HAYWOOD HOMES
BERRY HILL ROAD, ADDERBURY, OXON
SECTION 278 AND 38 WORKS
STAGE 1 ROAD SAFETY AUDIT

SA 3808
September 2022

Image Nr 4

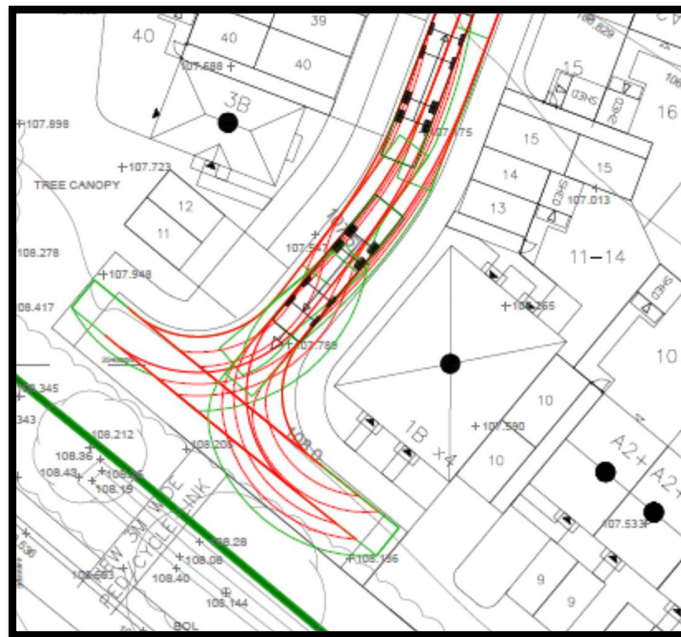
Drawings for vehicle swept paths for a 4-axle refuse vehicle and a fire appliance have been submitted for analysis. An extract of the swept path for a 4-axle refuse vehicle is shown in image number 4 above. The swept path shows how the vehicle will carry out a 180° manoeuvre to leave the turning head in a forward gear. Unfortunately, the swept path shows that the vehicle has to mount the eastern kerb in order to carry out this manoeuvre, with the risk of colliding with a pedestrian walking along the path. This situation may result in injuries.

It is recommended that the design of the turning head is adjusted to ensure that the swept path for a 4 axle refuse vehicle does not mount any kerbs and therefore prevents potential conflicts with pedestrians.

Image Nr 5

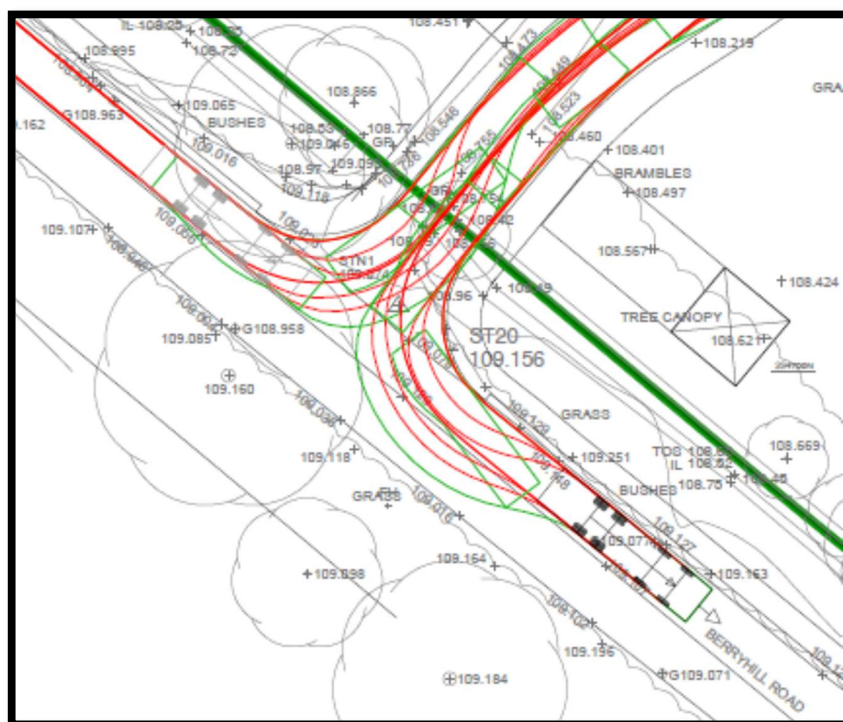
An extract of the swept path for a 4 axle refuse vehicle is shown in image number 5 above. The swept path shows how the vehicle will enter and leave the development Road 1. It also shows that when the vehicle leaves the site, it has to use the opposing lane in order to continue its journey eastwards. As Berry Hill Road is a very well used road, there is the risk of vehicle collisions between the refuse vehicles and other road users. This may result in injuries.

It is recommended that the design of the radii at the junction is amended to ensure that the swept path for the vehicle does not enter the opposing lane.
